Agenda Item: 5
BAR Meeting: 9/18/2019

Board of Architectural Review

DATE: September 18, 2019
TO: Board of Architectural Review Chair and Members
THROUGH: Jason Sutphin, Community Development Division Chief JDS
FROM: Tommy Scibilia, BAR Liaison TS
SUBJECT: Wawa

1. Case Number:	BAR-19-00547
2. Addresses:	9700 Fairfax Boulevard
3. Request:	New gas station
4. Applicant:	9700 Fairfax Boulevard LLC
5. Applicant's Representative:	Robert Brant
6. Status of Representative:	Agent
7. Current Zoning:	CR Commercial Retail, IH Industrial Heavy, Architectural Control Overlay District
8. Proposed Zoning:	CR Commercial Retail, Architectural Control Overlay District

CANOPY END ELEVATION

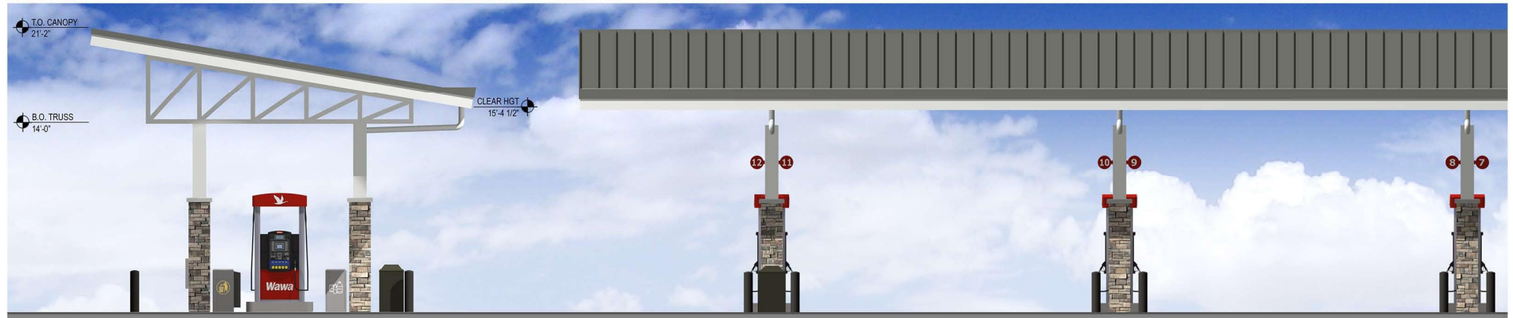
The proposed canopy design uses the same colors and materials as the grocery store building and the dumpster/toolshed enclosure, and although the structure is freestanding and not integrated into the structure of the building, staff finds its design to overall conform to this additional consideration for gas stations.

Staff finds the design of both the canopy over the covered walkway and the freestanding fuel pump canopy to conform to the above guidelines. The materials and colors are appropriate and compatible with the design of the grocery store building, and the design of the freestanding canopy and its angle preserve views of the grocery store from the right-of-way.

FRONT ELEVATION

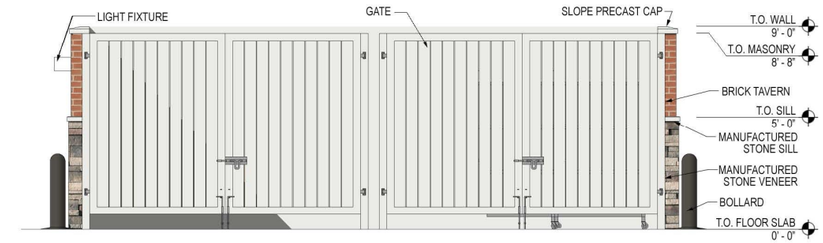
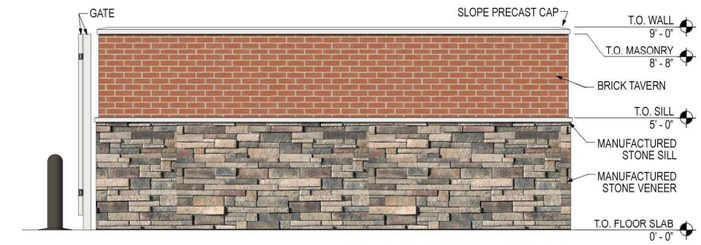
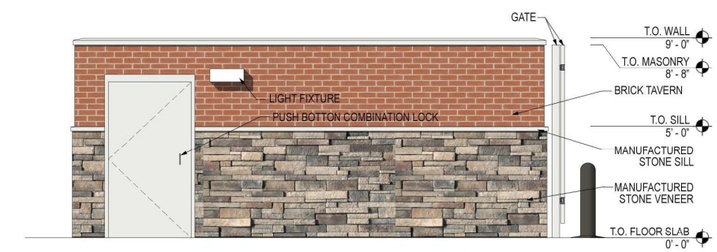
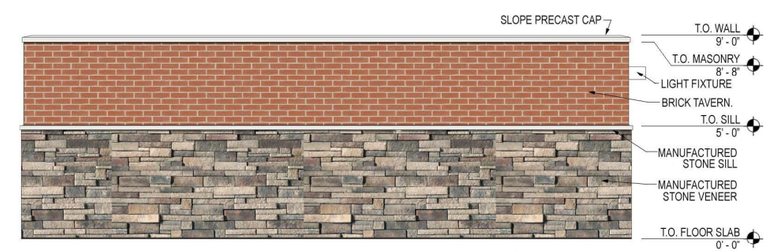
The mechanical equipment for the grocery store is to be roof-mounted and fully screened from view, consistent with this guideline. Staff finds the proposed use of dwarf Japanese hollies to be an appropriate screen for the electrical transformer. The primary loading area is located on the rear elevation of the grocery store building, consistent with these guidelines. The dumpster enclosure would comprise of the same high quality materials proposed for use on the grocery store building, and its siting in the back corner of the site is appropriate.

Photometric Plan

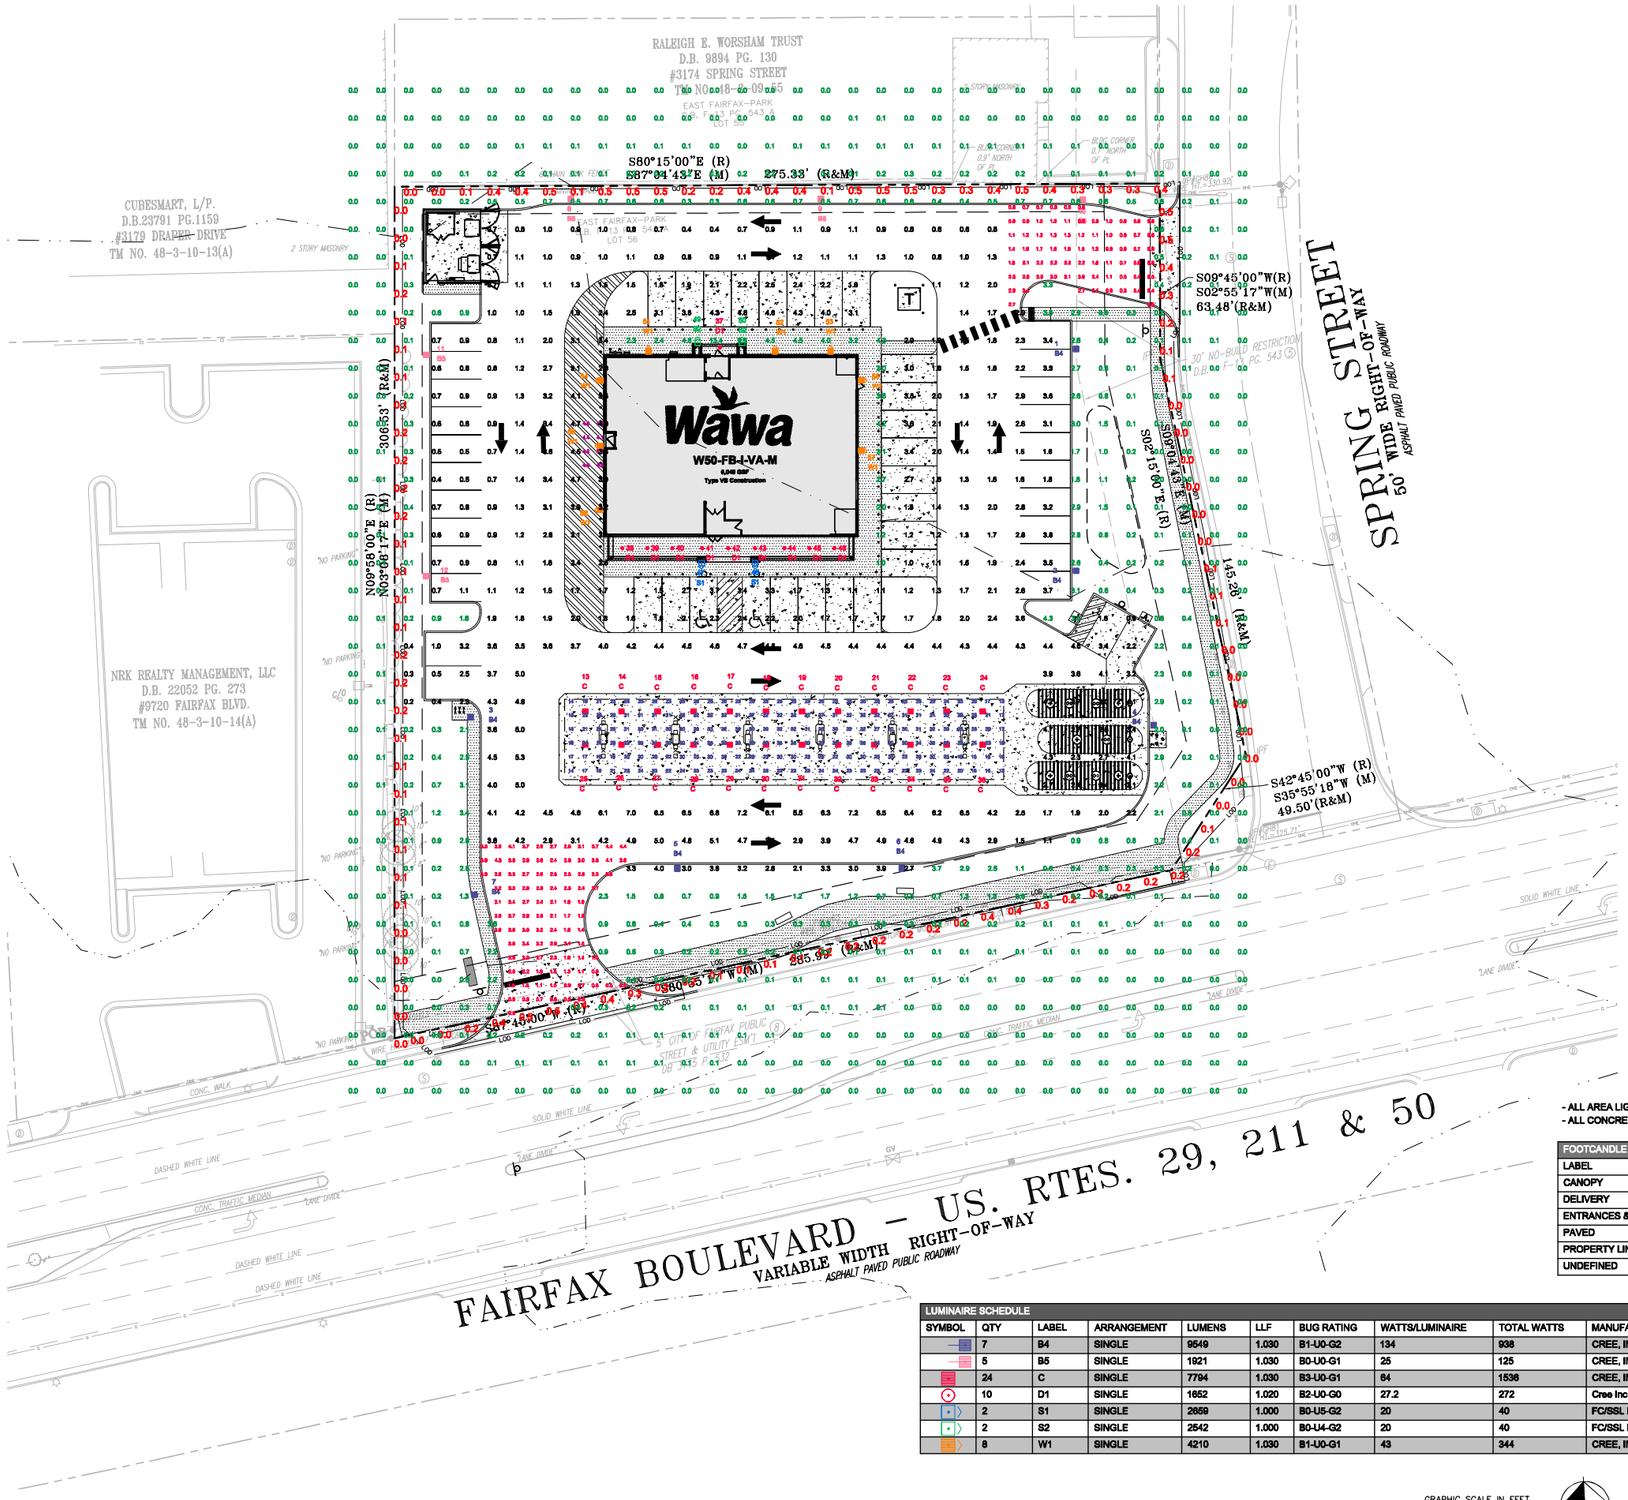
Staff finds the proposed sconces at the entrances to be appropriate decorative lighting features that fit into the design language of the rest of the building. The downcast security lights are appropriate for service areas where they are proposed. All fixtures utilize an LED lighting source, consistent with the above guideline. Staff believes that all lighting fixtures should be in a dark bronze finish, rather than a white finish, as this finish is easier to maintain and consistent with fixtures found throughout the City (see Recommendations).

1. All lighting fixtures shall be in a dark bronze finish, and illumination levels shall be subject to review and approval by the Zoning Administrator.
2. Additional shrubs and groundcover shall be installed within the parking islands, along the Fairfax Boulevard and Spring Street frontages, and along the western landscape area.
3. The proposed modifications shall be in general conformance with the review materials received by staff and included in the staff report, as modified through the date of this meeting, except as further modified by the Board of Architectural Review, the Director of Community Development and Planning, Zoning, or the Building Official.
